NASA Technical Memorandum 102012

Summary and Evaluation of the Strategic Defense Initiative Space Power Architecture Study

ABSTRACT

TRW-PLASMA ENVIRONMENT

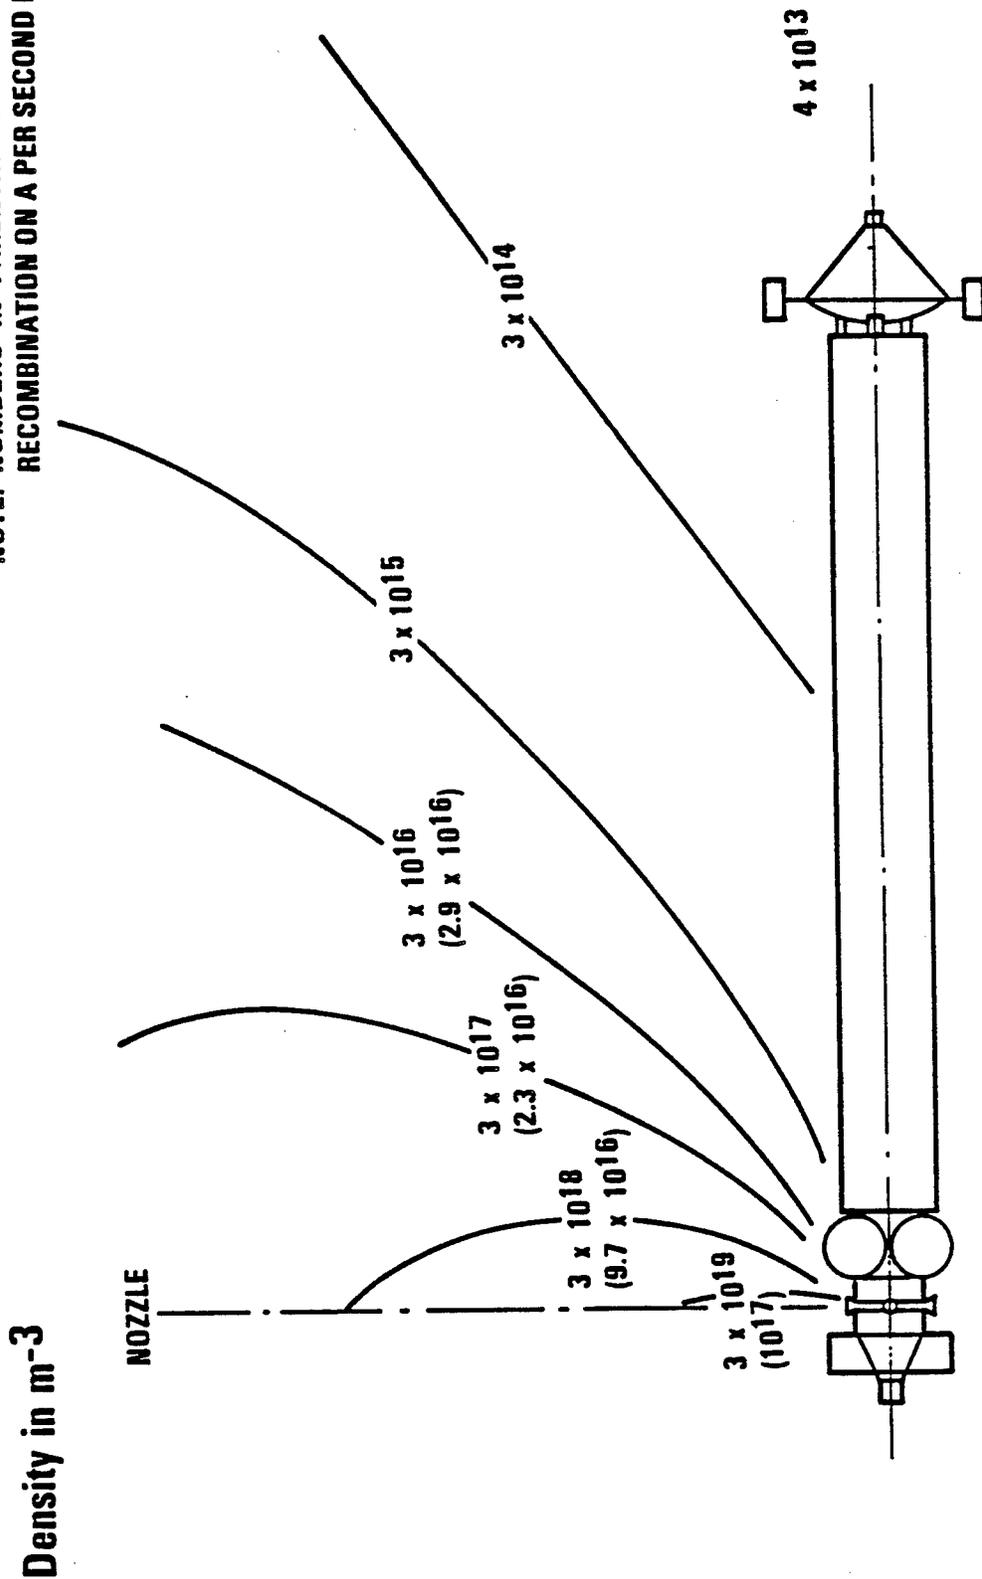
The final report does not address plasma issues in a separate section. Plasma due to ionization of effluents and directly emitted from the MHD system are treated as part of the "effluent" discussion. It is noted on Page 3.10-29 that the design assumption is that high voltage is fully shielded from external plasma, which obviates the need for treatment of plasma-high voltage issues. The geomagnetic substorm environment is noted on page 2-109, and conducting external surfaces, grounding and shielding are recommended. The possibility of arcing due to internally generated plasmas is noted on page 2-110. The importance of maintaining the integrity of the high voltage insulation is noted in several places.

TRW-THERMAL ENVIRONMENT

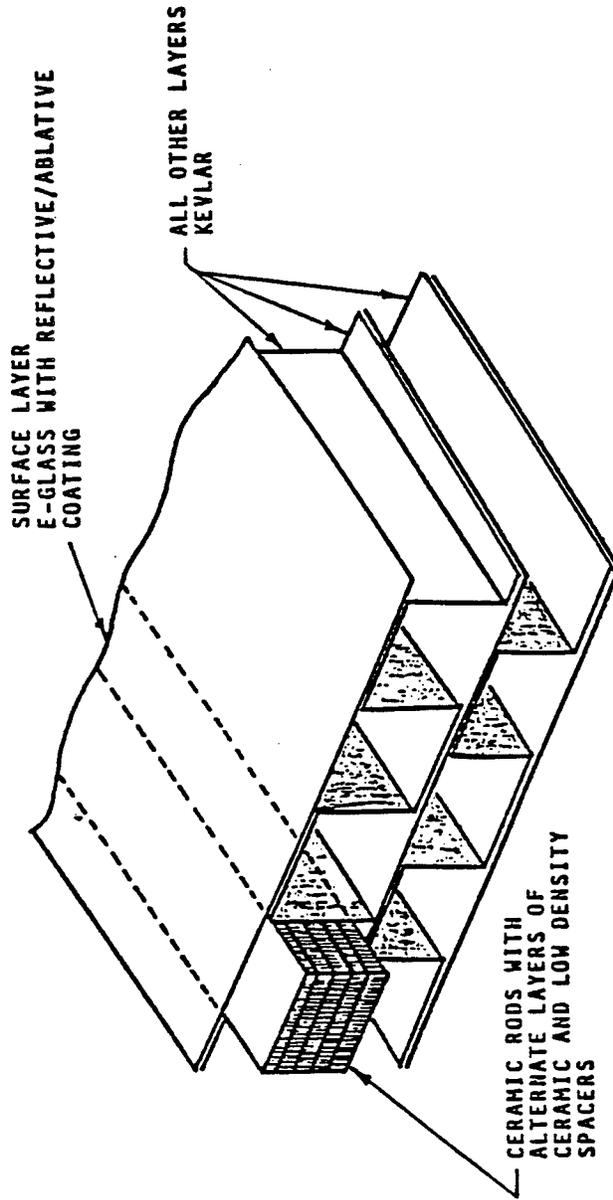
Again the treatment seems rather cursory. The questions of self-induced heat and solar heat input are not addressed.

Specific Mass of 10MW Radiators

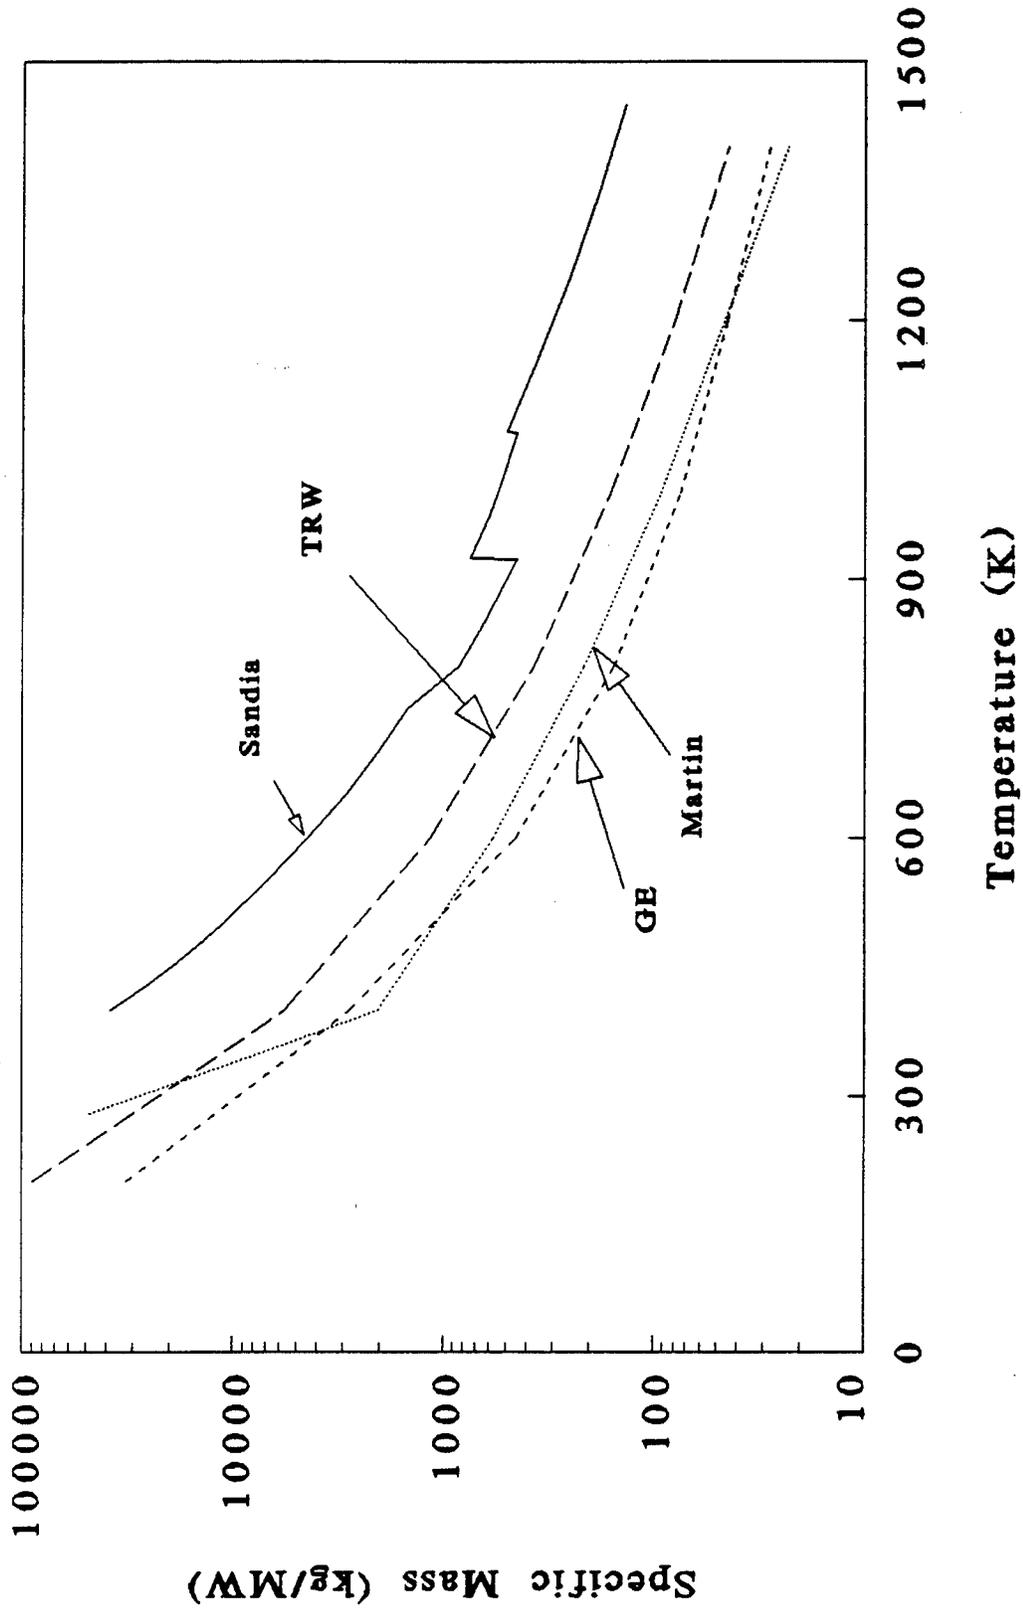
This graph presents the specific mass estimates (kg/MW) of heat pipe radiators that were made by the three contractors as a function of temperature. These estimates are compared with preliminary estimates made by Sandia for armored radiators. The Sandia estimates were made using the code MACRAD. (MACRAD is a code that is being developed to estimate and optimize the mass of heat pipe radiators. It is a parametric code that calculates masses based on heat pipes that meet operational requirements, e.g., the capillary limit, and uses temperature dependent material properties.) The contractor estimates are basically consistent with the mass of unarmored heat pipes. However, when armoring is taken into account, the contractor estimates are low.
